WING FAIRED STEP-PLAN-SYMMETRICAL WITH-WING HEATER INTAKE DUCT

CONSOLIDATED AIRCRAFT CORP. SAN DIEGO, CALIF.

28F6723

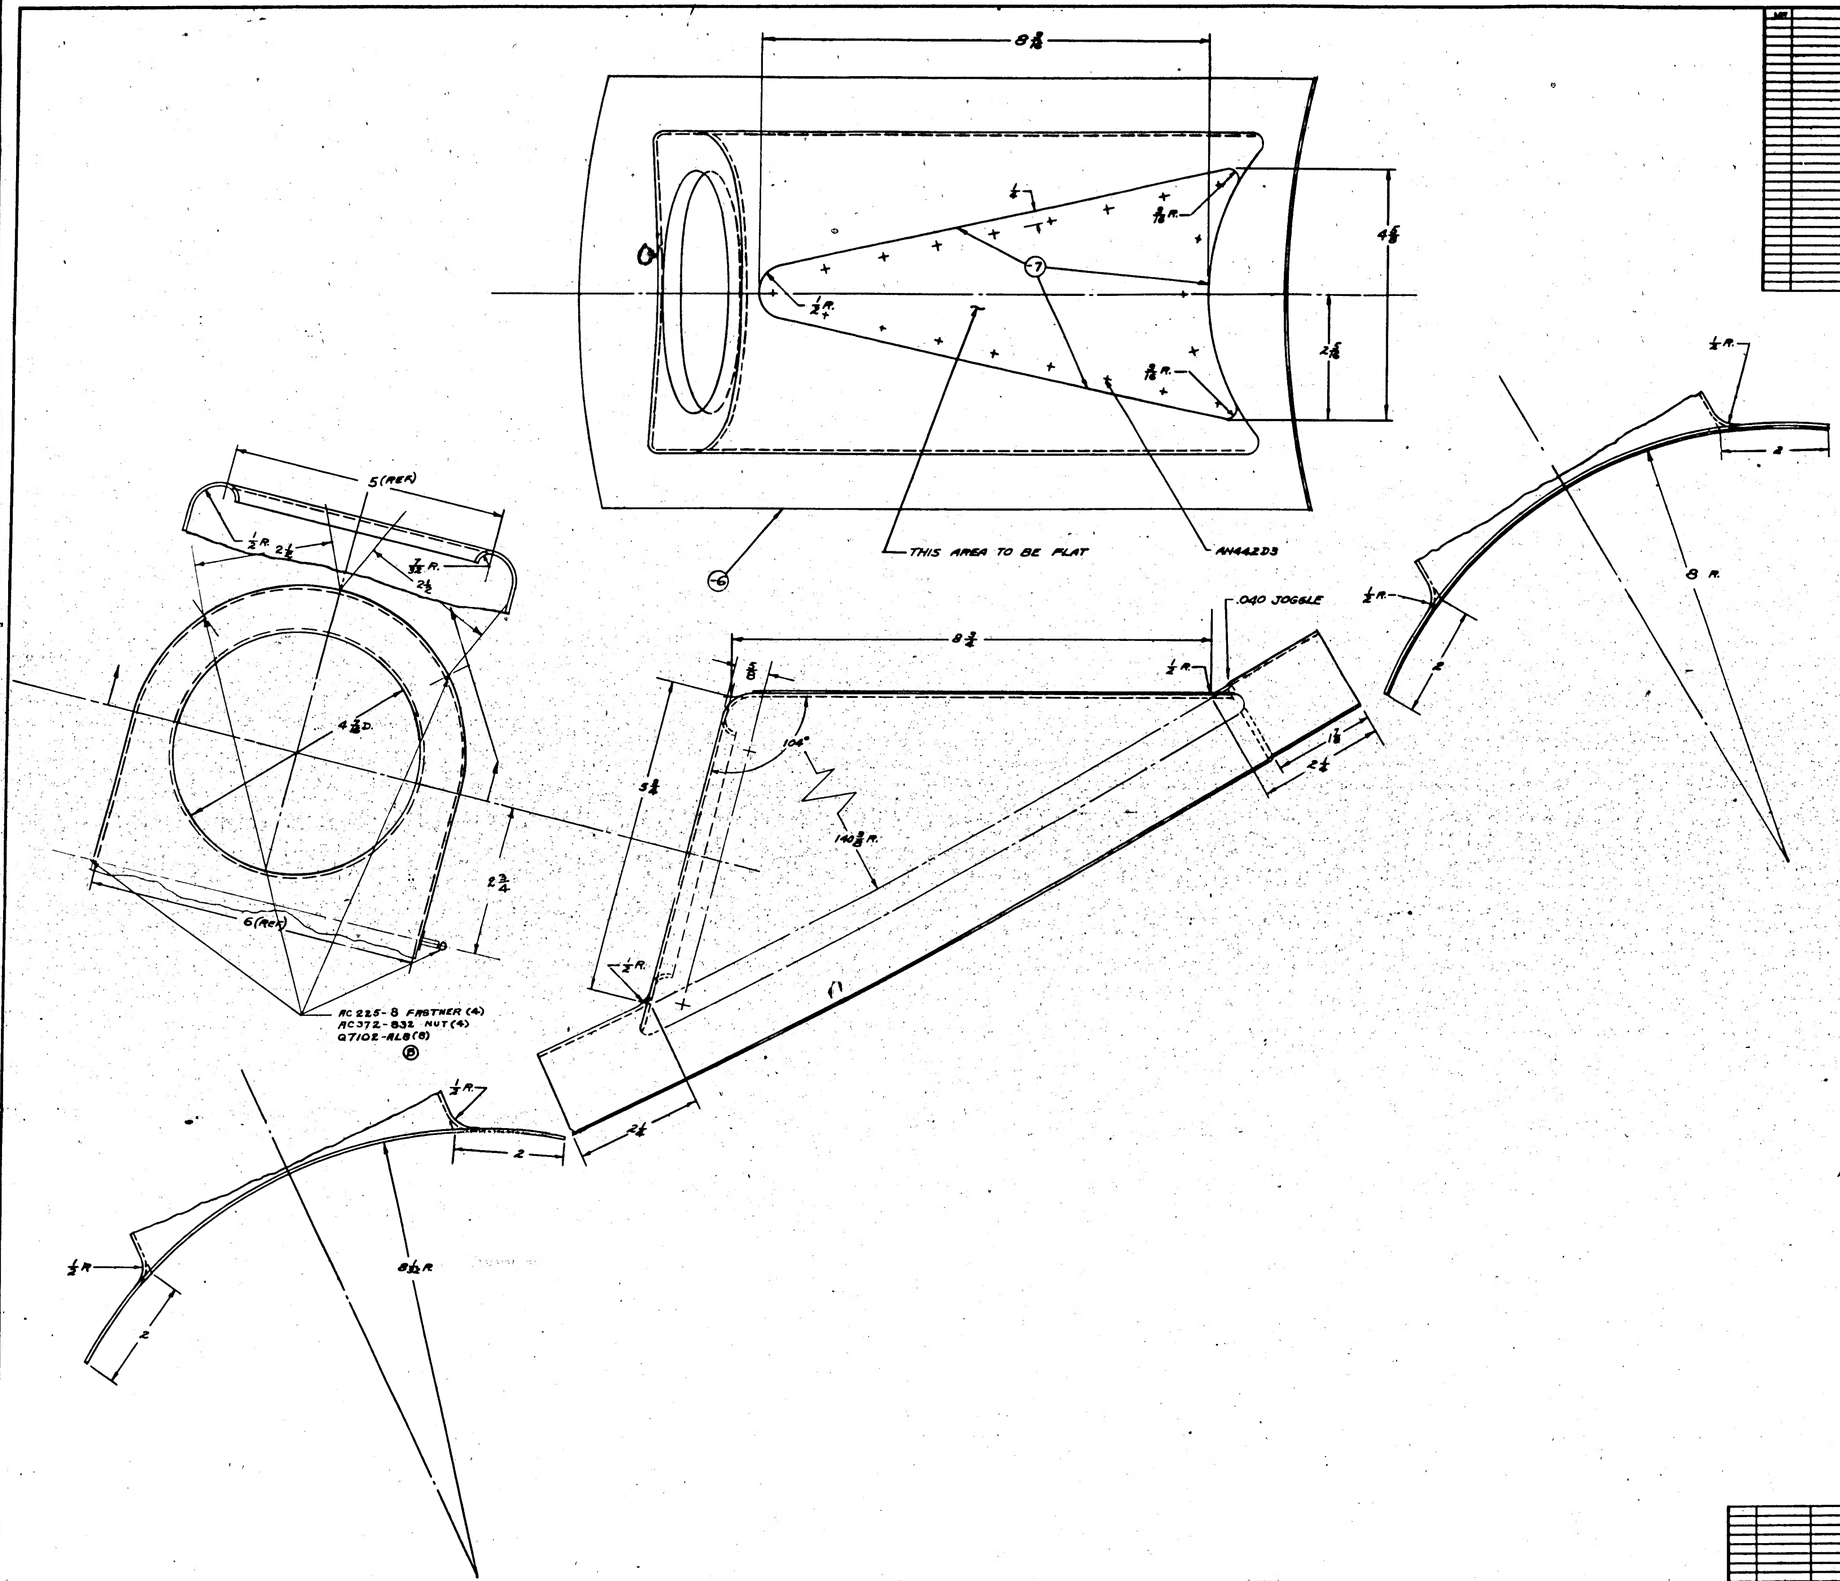
LET	ALTERATION	DATE	MADE	LET	ALTERATION	DATE	MADE
				B	BOSS 3/8 DIA. REMOVED 3/8 DIA. 7/8 DIA TO INSTALL 3/4 DIA. BOSS. BOSS & FASTENERS TO EACH SIDE		
						8-10-43	E.O. 8151-GA
				B	ADDED AC 372-832 NUT & Q7102-AL8 WASHER TO EACH SIDE OF BOSS & ADDED AC 225-7 SCREW & WASHERS.	10-9-43
